## *City of El Paso – City Plan Commission Staff Report*

**Case No:** SUSU14-00066 Corner Bakery Subdivision  
**Application Type:** Major Combination  
**CPC Hearing Date:** August 14, 2014  
**Staff Planner:** Nelson Ortiz, (915) 212-1606, [ortiznx@elpasotexas.gov](mailto:ortiznx@elpasotexas.gov)  
**Location:** North of Edgemere and West of Airway  
**Acreage:** .8775 acre  
**Rep District:** 3  
**Existing Use:** Commercial  
**Existing Zoning:** C-4 (Commercial)  
**Proposed Zoning:** C-4 (Commercial)  
**Nearest Park:** Across from Edgemere linear park  
**Nearest School:** Bonham Elementary School (.09 mi.)  
**Park Fees Required:** \$880.00  
**Impact Fee Area:** N/A  
**Property Owner:** EP Marcus Investments, LP  
**Applicant:** Bakery Venutre, LLC  
**Representative:** Conde, Inc.

The applicant proposes to subdivide a .8775-acre commercial lot at the northwest corner of Edgemere and Airway Boulevards with access proposed from Edgemere. The applicant has requested a waiver for roadway improvements to Airway Boulevard. Airway Boulevard is designated as a major arterial (100' ROW) on the Major Thoroughfare Plan. This development was reviewed under the current code.

**PRELIMINARY PLAT**

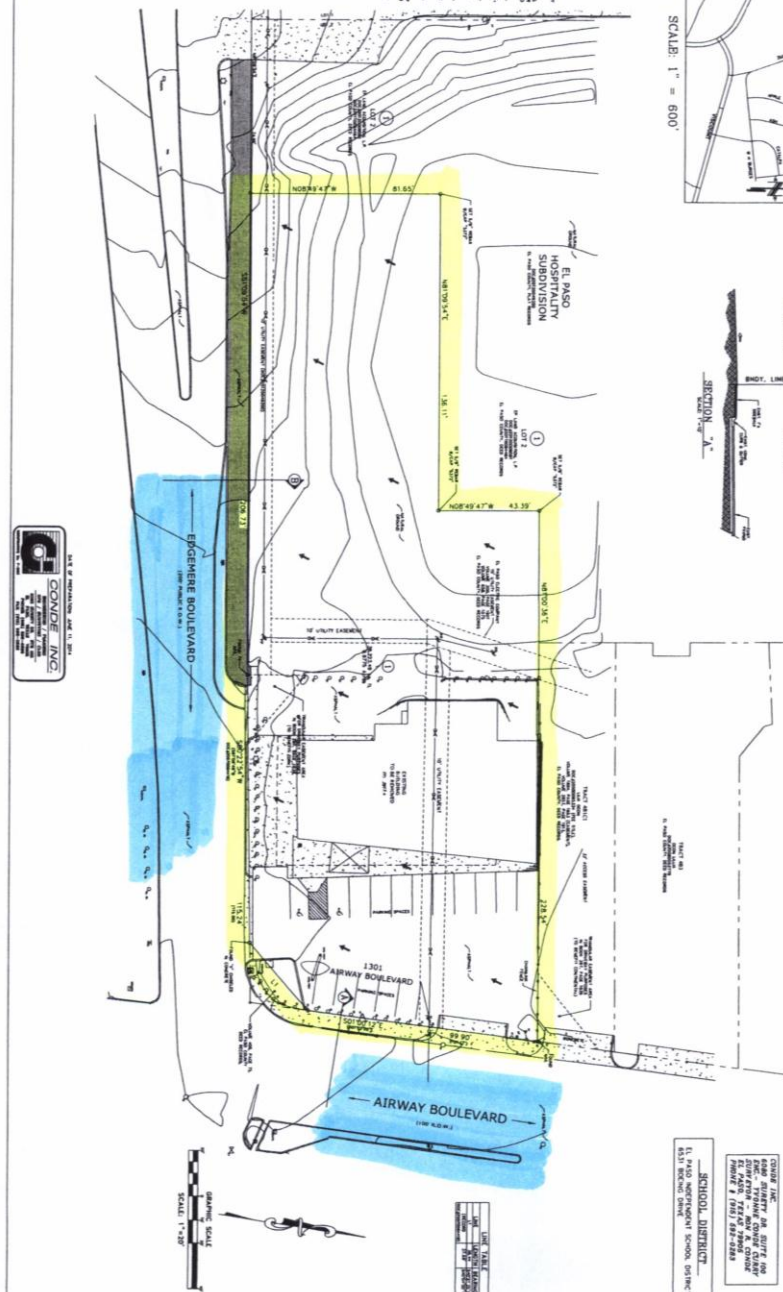
- a. EPWU may require retention of all developed storm-water runoff within the subdivision.
- b. The Storm-water Master Plan recommends increasing capacity of existing culvert; storm-water discharge will need to be reviewed before approval.

Along Edgemere Boulevard between Robert E. Lee Boulevard and Airway Boulevard there is an existing twenty-four (24) inch diameter water transmission main. This main is located at approximately 165 feet south of the northernmost right-of-way of Edgemere Boulevard. No direct service connections are allowed to this main as per the El Paso Water utilities – Public Service Board (EPWU-PSB) Rules and Regulations.

Along Airway Boulevard between Edgemere Boulevard and Montana Avenue there is an existing twelve (12) inch diameter water main. This main is located at approximately 34 feet west of the easternmost right-of-way line of Airway Boulevard.

Additional water services to this Property are anticipated by means of the extension of a water main perpendicular to Edgemere Boulevard fronting the Property from the described 24-inch diameter main that runs along Edgemere Boulevard. All main extension costs are the responsibility of the Owner/Developer. Easements immediately north of Edgemere Boulevard may be required to accommodate the proposed additional water services for this Property.

Along Edgemere Boulevard between Robert E. Lee Boulevard and Airway Boulevard there is an existing eight (8) inch diameter sanitary sewer main. This main is located at approximately 70 feet north of the southernmost right-of-way line of Edgemere Boulevard. This main dead-ends at approximately 490 feet east of Robert E. Lee Boulevard.

- Extend the hike and bike trail system and curb to corner of Edgemere and Airway Boulevards.
- Modify corner curb and bring into ADA compliance. This will require traffic signal infrastructure modifications. Please coordinate with EPDOT for cost and modifications.

Recommend the placement of sidewalks and ADA compliant improvements throughout the development to City standards to provide pedestrian accessibility to mass transit services.

1. Submit to the City Development Department – Planning Division the following prior to recording of the subdivision.
  - a. Current certified tax certificate(s)
  - b. Current proof of ownership
  - c. Release of access document, if applicable
  - d. Set of restrictive covenants, if applicable
2. Every subdivision shall provide for postal delivery service. The subdivider shall coordinate the installation and construction with the United States Postal Service in determining the type of delivery service for the proposed subdivision. In all cases, the type and location of delivery service shall be subject to the approval of the United States Postal Service.
3. Provide full cross-sections with dimensions for both Airway and Edgemere Boulevards.
